GROUP 54A

CHASSIS ELECTRICAL

OUTLINE OF CHANGE

<Rear speaker>

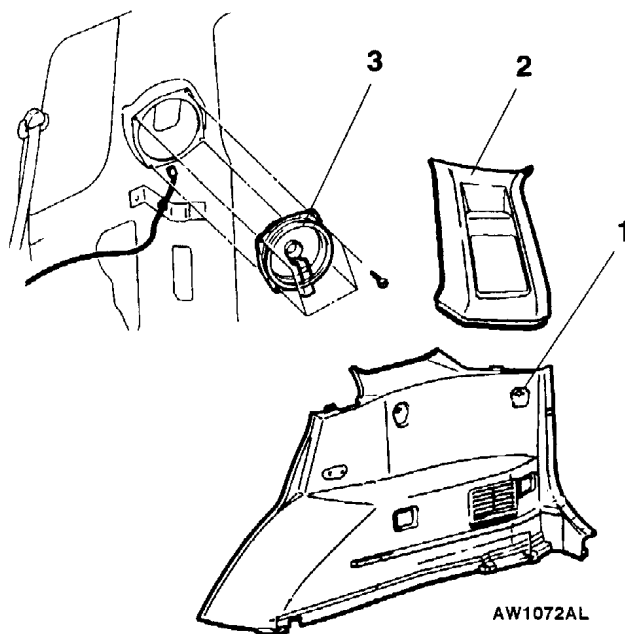
- Due to the introduction of 5-door models, the rear speaker service procedure has been changed.

Rear speaker removal steps

1. Quarter trim, lower (Refer to GROUP 52A.)
2. Rear pillar trim (Refer to GROUP 52A.)
3. Speaker
